City of Portland
Development Review Application
Planning Division Transmittal form

Project Name: DOUGHERTY FLD. IMPROV.
Address: 91 Douglass St **CBL:** 066 - A-002-001

Project Description: Dougherty Field Improvements Phase 1; Douglass/St. James Street;
City Of Portland, Applicant.
Zoning: ROS

Project Name: Dougherty Field Improvements Phase 1
City of Portland, Applicant.
Project ID: 10-79900030 **CBL:** 066-A-002-001
Project Address: Douglas Street/ St. James Street
Planner: Jean Fraser

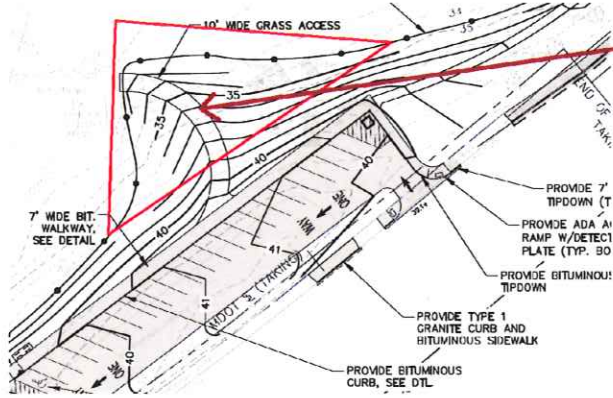
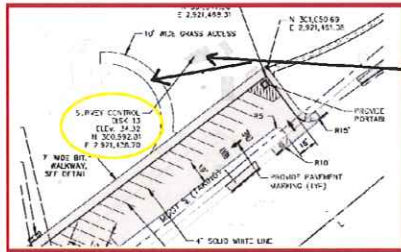
I do not want that structure over the survey mark. Nor do we want that 10' road down from the parking lot. It was never suppose to be there and I was told instead of changing the drawings it would be an infield decision.

Do not create this grass walk way. It will be a mowing night mare and no one will use it anyway. I don't want dirt grade out too far from the parking lot because you will start interfering with the area round the baseball field.

This survey control should not be covered by dirt so there is no reason for the structure. The 10' grass access road is not needed and should not be put in.
